SUBARU

NUMBER: 16-112-18R

SERVICE BULLETIN

Ignition Key Sticking / Design Change to CVT

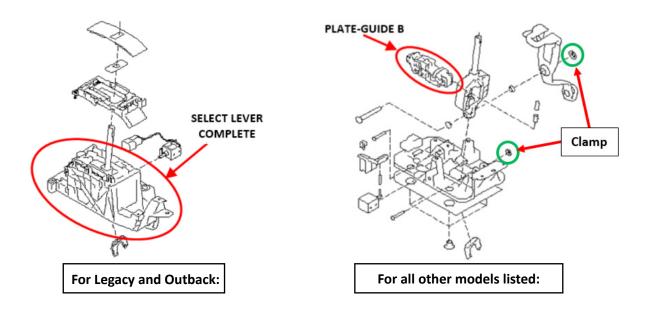
The term PLATE-GUIDE B refers to the Park-Range switch which is a serviceable part of the select lever assembly on all models listed above **EXCEPT** Legacy and Outback. See the illustrations provided below for more details.

• For **Legacy and Outback**, the shifter assembly (SELECT LEVER COMPLETE) must be replaced if the Park-Range switch is found to be faulty.
